**Information technology — Radio
frequency identification for item
management —**

**Parameters for air interface
communications at 860 MHz to 960 MHz**

**AMENDMENT 1: Extension with Type C and
update of Types A and B**

Amendment 1 to ISO/IEC 18000-6:2004 was prepared by Joint Technical Committee ISO/IEC JTC 1, *Information technology*, Subcommittee SC 31, *Automatic identification and data capture techniques*.

Figure 16 — Tag state transition diagram

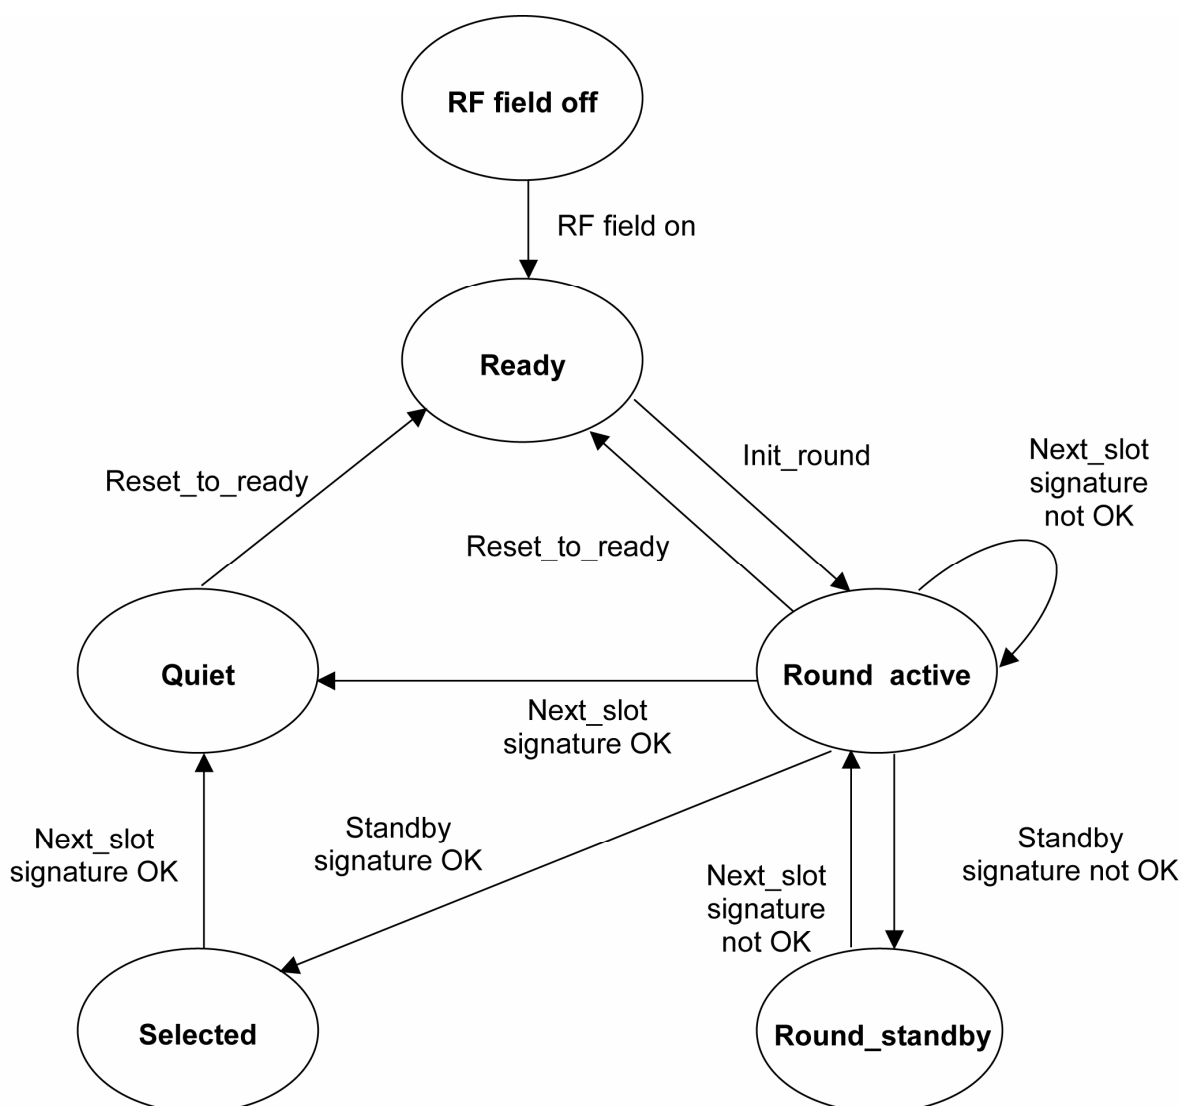
Page 35, Figure 16

Replace Figure 16 with the following new Figure 16.

NOTE This state diagram shows some of the main transitions. State transitions are specified in detail in each command description.
